## MEMORANDUM

**To:** The Design Advisory Board  
**From:** Mary O'Neil, AICP, Principal Planner  
**RE:** ZP21-479, 1-7 Church Street  
**Date:** June 22, 2021

**Location:** 1-7 Church Street (Masonic Temple)

**Request:** Alternative/Alternate Compliance for blade sign.

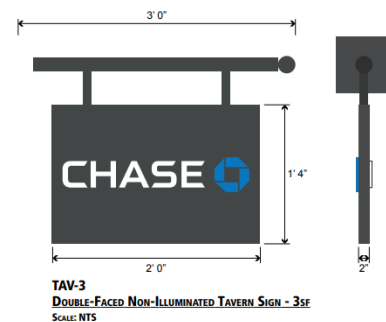
*b) The relief, if granted, will yield a result equal to or better than strict compliance with the standard being relieved;*

The proposed installation site will center the blade sign on an existing pier; a visually and functionally more appropriate installation location for the blade sign.
